## Change Order Number 3

Date: December 22, 2022  
 To: ESCO Construction Co.  
 From: City of Grand Junction, Department of Public Works and Utilities  
 Project: **Hogchute (AKA Carson) Reservoir Dam Rehabilitation**  
 P.O.: **2021-00000729**

**Hogchute (AKA Carson) Reservoir Dam Rehabilitation -- City P.O. No. 2021-00000729**  
**Change Order No. 3**

Figure 1

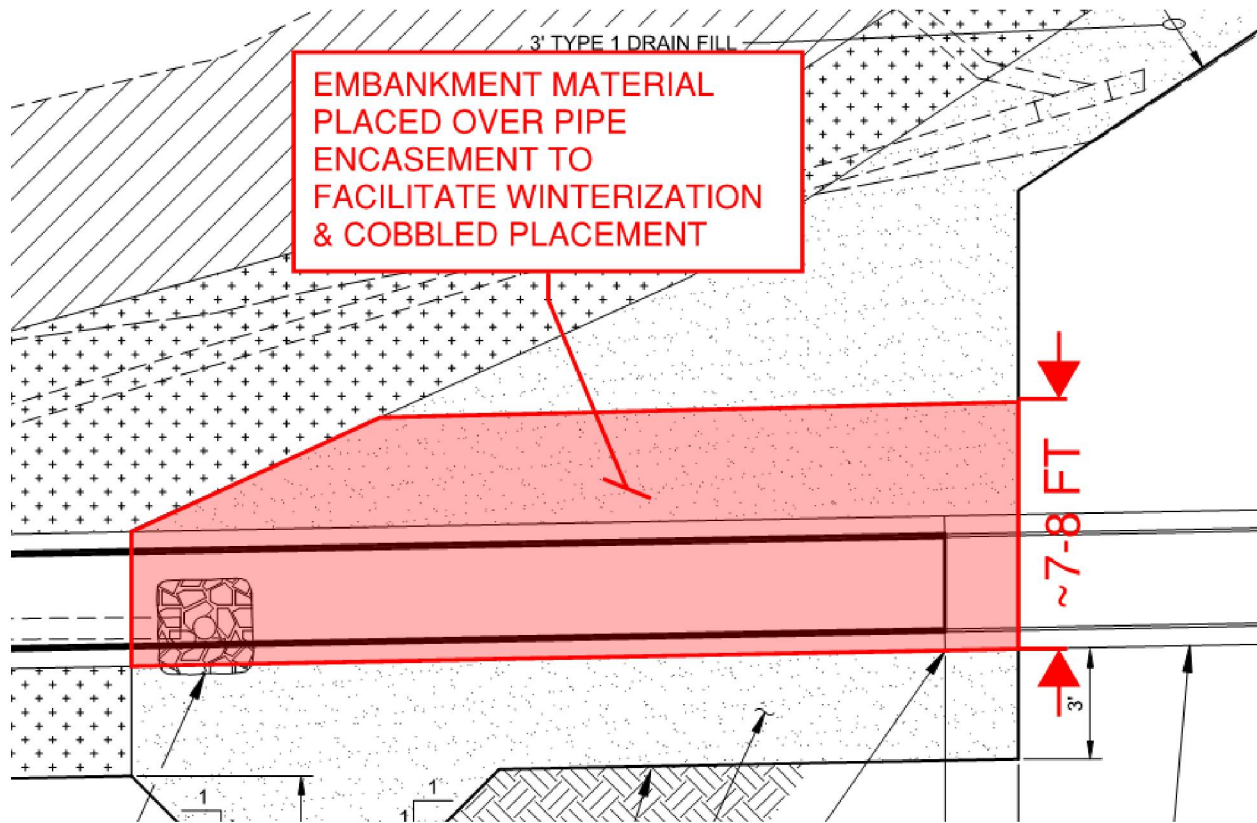
- d. There is no accurate comparison to the original contract work for line item COR4A.08 Expose Filter Diaphragm. In order to winterize the project and place cobble on the downstream side embankment material had to be placed over top of the filter diaphragm (see figure below).

To complete the filter diaphragm work in 2022 the embankment material placed for winterization will need to be removed. Due to the location of the work and since the pipe encasement has been installed this work will be slow and need to be done very carefully to prevent damage to the encasement. It is also anticipated that the top layer of the drain sand will need to be removed and replaced due to contamination of the filter sand before the diaphragm can be brought up to its final grades.
